RE: LERNER STORE-PORTLAND, MAINE.

Replying to your letters of August 30th and 31st concerning the proposed building for Lerner Stores Inc. at 501 Congress Street, this City, there are just two items that appear to be unsettled.

Replying to your inquiry of October 17th concerning revised plans for the building for Lerner Stores at the corner of Oak and Congress Streets, this City, we have the following criticisms:

REVISED FLOOR PLAN OF REPAIRS FOR
JOHN HOLEMAN
DESIGNING DEPT. OF THOMPSON & WINGHEATER CO.
SCALE 1/4" = 1'-0"
SEPT 3 1940 BY J. H. HANCOCK

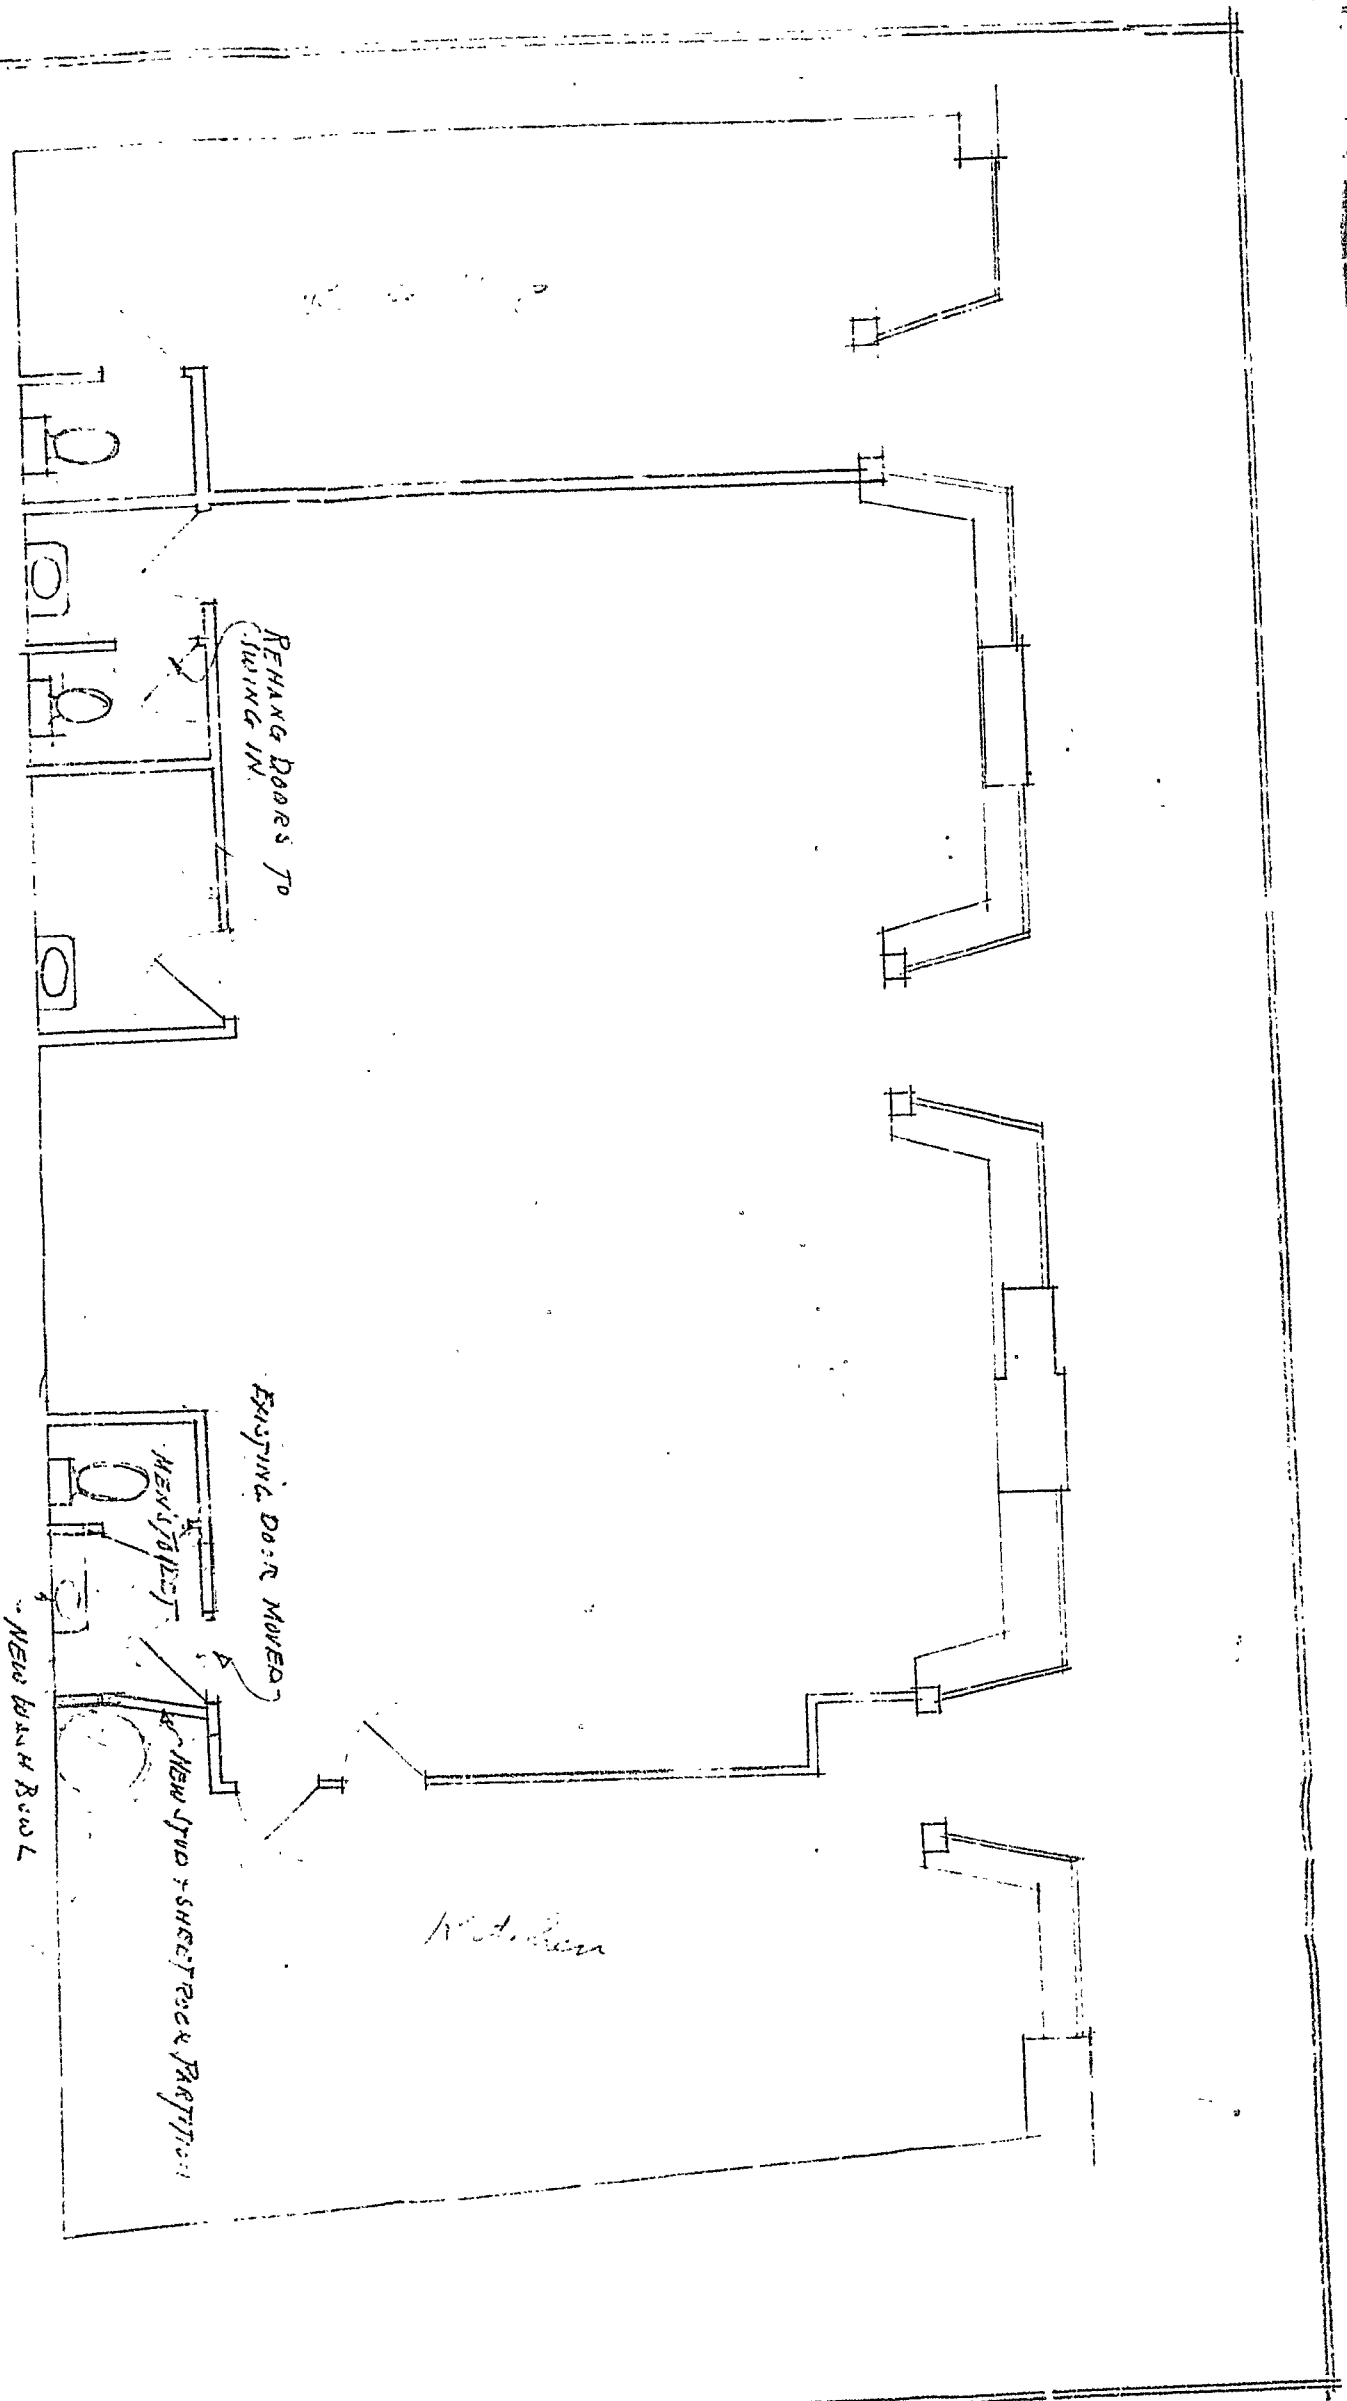
Referring to your application for a permit to make alterations in the building at 77-79 Oak Street in this city for John Holevas, Lessee, some of the details of the plan do not satisfy the requirements:

The existing toilet is shown to open directly into the kitchen without any vestibule contrary to both the Building Code and the health regulations. It is also necessary that you show on the plan and supply a lavatory for the employees of the restaurant in a location approved by the Health Department.

The swing of the doors of toilets and vestibules serving the kitchen to the restaurant should be changed, so that the swing of them will not interfere as indicated on the plan. I see no reason why both vestibule doors could not swing into the restaurant and thus avoid interferences.

The door from restaurant to kitchen which swings into the kitchen is required as an exit door for patrons thence through the kitchen to the outside door on to Oak Street. There should be an exit sign with letters no less than four inches high shown over this door from restaurant to kitchen, shown on the plan and provided.

A note should be added to the plan to the effect that both doors leading to Oak Street will be equipped with such locksets that persons on the inside can always leave without the use of a key, merely by turning the usual knob.

Please have the plan corrected, consulting the Health Department, and file new prints, so that we may issue the amendment.
